Subject: Proposed Hydrostratigraphic Nomenclature – Black Mountain Industrial Complex and Common Areas

Comments on the Proposed Stratigraphy and Hydrogeologic Nomenclature for the BMI Complex and Common Areas

Plate 2 Comments

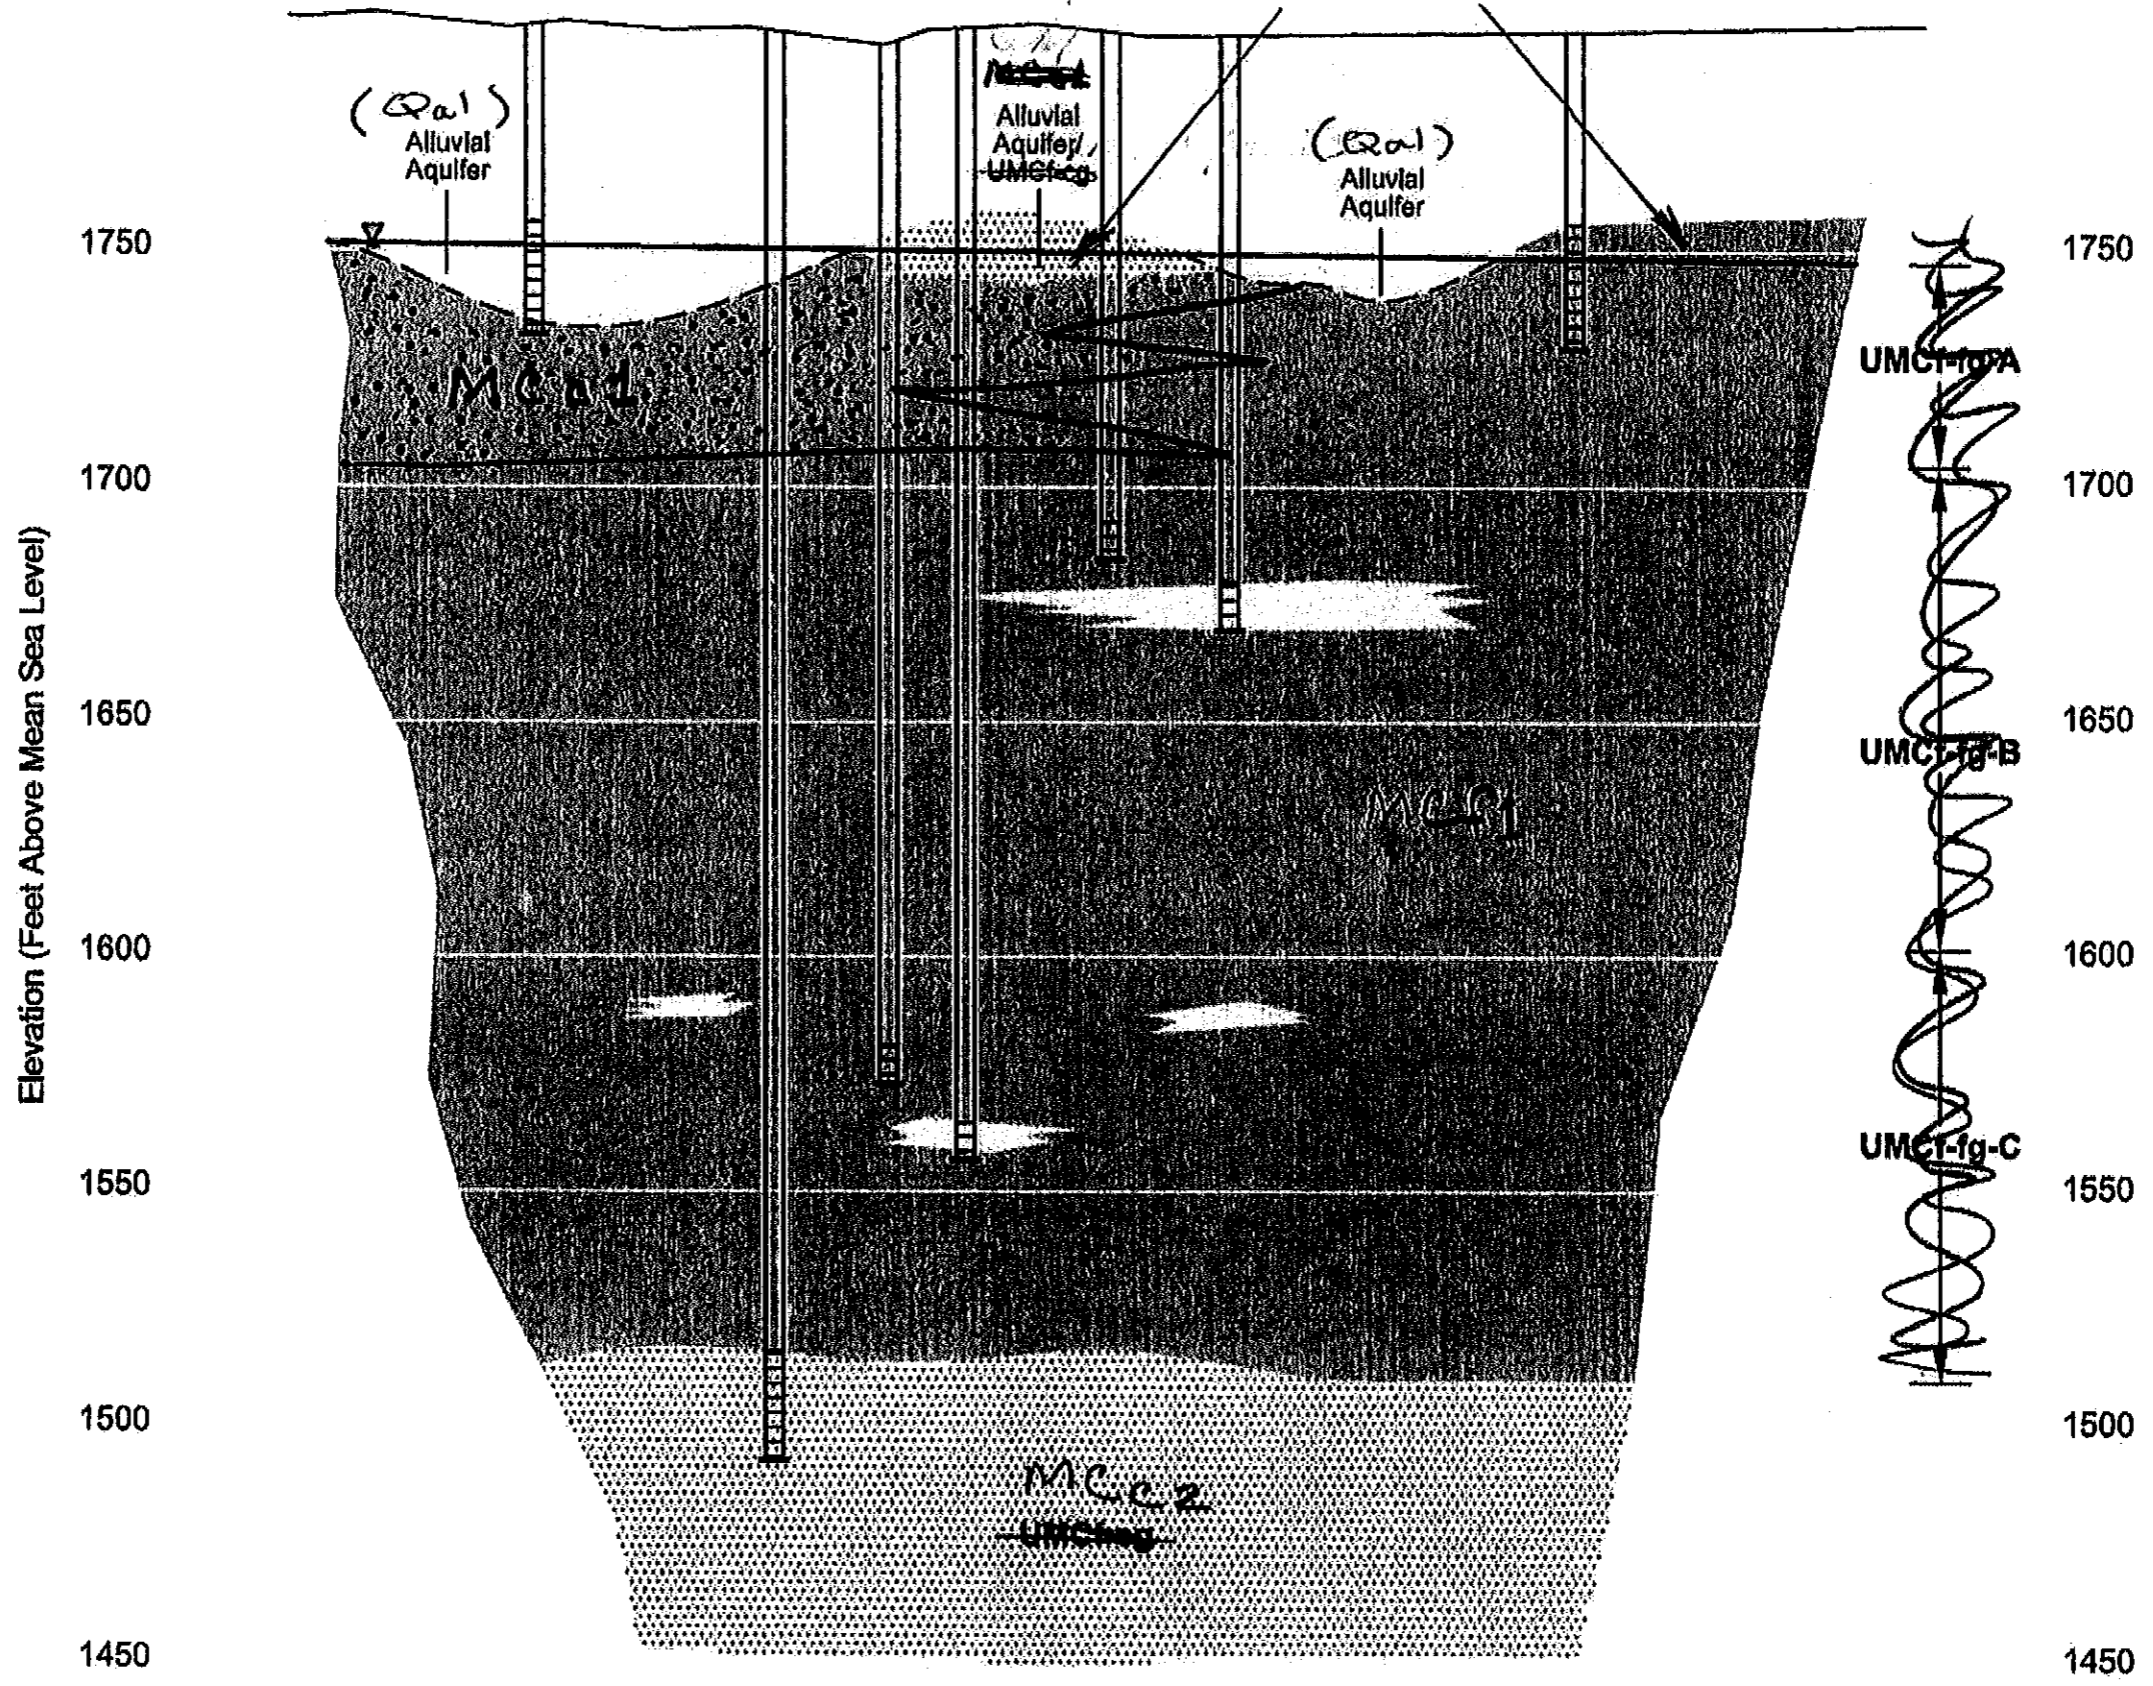
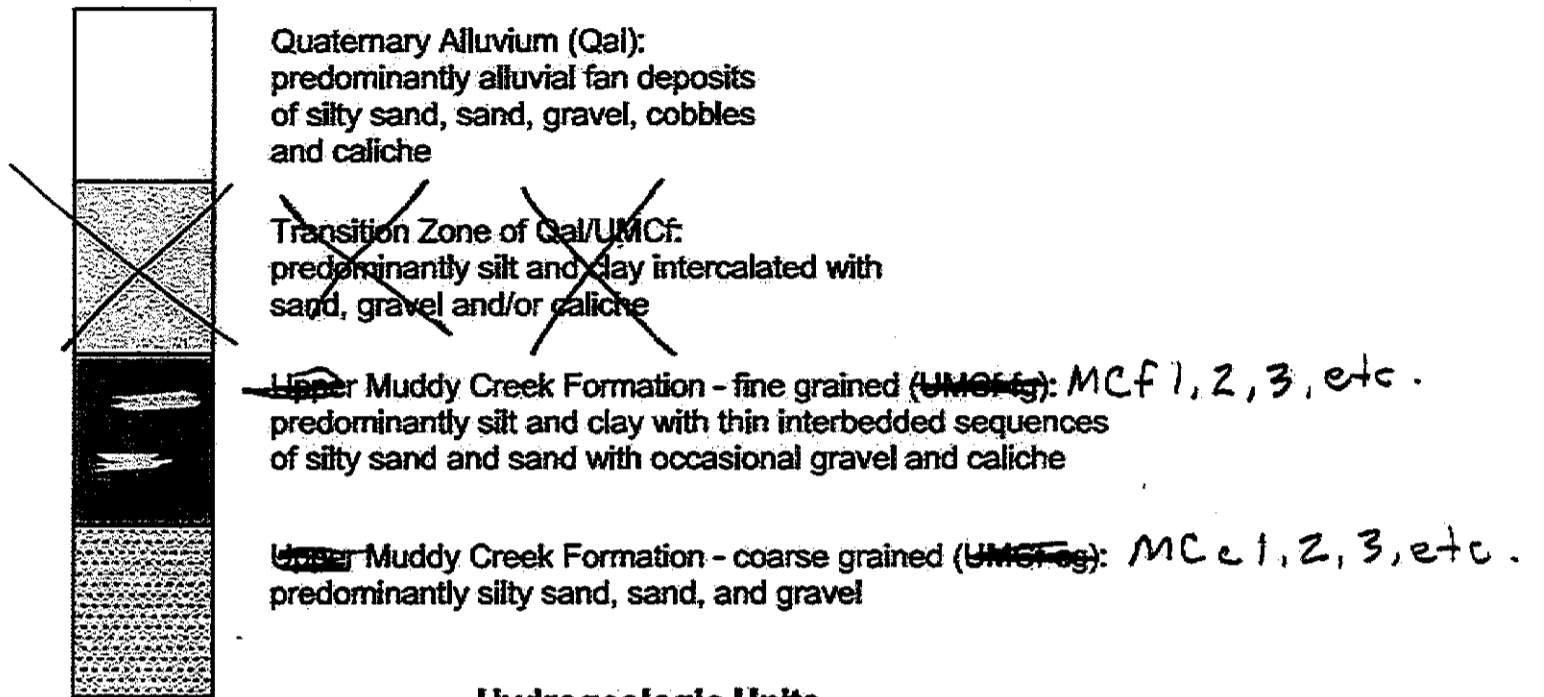
As noted above, none of the authors dealing with the MC in LVV described "transitional" MC in any of their investigations. The proposed nomenclature document states that hydrologic investigations in the BMI areas have revealed the presence of a reworked "Transition Zone" of sediments between the base of the Qal and top of the MC. Tronox mapping from Lake Mead Parkway to LVW has found very little reworked MC. What has been observed are thin, isolated and discontinuous reddish brown silty fine grained sands with or without granules or fine pea gravel, and with or without pedogenic caliche nodules or layers. The word "transitional" means changing gradually over time or space. The reworked MC does not fit this definition and the use of the word "transitional" should be abandoned. If reworked MC is found in an area it probably occurs in depressions or alluvial channels eroded into the MC (**see Plate 2 for an example**) and

(1) The UMCf-fg-“A”, “B”, “C” units are segregated by depth (**see Plate 2**). Because of the relative uniformity of the fine-grain MC, the document author may have seen this as a necessity. Tronox is concerned though that “depth” has nothing to do with hydrostratigraphy. The site topography changes from south to north, and a “B” unit below the site, will not be the same “B” unit adjacent to the LVW. It would be preferable to segregate the units by lithology and hydrogeologic characteristics, not depth, as “depth” changes with variable topography.

(4) The revised **Plate 1** and **Plate 2** shows the preferred naming of the geologic and hydrogeologic units. They are the following:

(Qal) can included saturated M.C. 1 and M.C. 1

| <p><i>MC saturated deposits of MCc1</i></p> <p><i>MCf1</i></p> <p>Near-Surface Aquifers of Maxey and Jameson (1948) and Plume (1989)</p> | <p>Alluvial Aquifer (Qal): For the purpose of developing common nomenclature throughout the BMI areas, saturated deposits within Qal and/or Transition Zone (typically exhibits unconfined conditions). <i>Can include</i></p> <p>Alluvial Aquifer (UMCf-ug): For the purpose of developing common nomenclature throughout the BMI areas, at locations along mountain fronts (e.g. adjacent to Lake Mead Parkway) where Qal deposits are immediately underlain by saturated deposits of UMCf-ug (typically exhibits unconfined conditions) or saturated deposits of MCf1 further north (typically exhibit unconfined conditions).</p> <p>UMCf-fg-A: For the purpose of developing common nomenclature throughout the BMI areas, where applicable the UMCf-fg-A is projected as saturated UMCf-fg deposits within the approximate upper 50 feet of UMCf-fg (typically exhibits semi-confined or unconfined conditions). <i>confined,</i></p> <p>UMCf-fg-B: For the purpose of developing common nomenclature throughout the BMI areas, where applicable the UMCf-fg-B is projected as the zone of saturated UMCf-fg deposits that range from approximately 50 to 150 feet below the top of UMCf-fg (typically exhibits semi-confined or confined conditions).</p> <p>UMCf-fg-C: For the purpose of developing common nomenclature throughout the BMI areas, where applicable the UMCf-fg-C is projected as the zone of saturated UMCf-fg deposits that range from approximately 150 to 350 feet below the top of UMCf-fg and above the UMCf-cg (typically exhibits semi-confined or confined conditions). In general, this zone represents the maximum depth of groundwater monitoring wells completed throughout the BMI areas.</p> | <p><i>and reworked include</i></p> <p><i>MCc1</i></p> <p><i>MCf1</i></p> |
| <p>Shallow Confined Aquifer of Maxey and Jameson (1948) and Plume (1989)</p> | <p><i>MCc2</i></p> <p><i>MCc2</i></p> <p>UMCf-cg: Saturated sediments within UMCf-cg (typically exhibits confined conditions)</p> | |
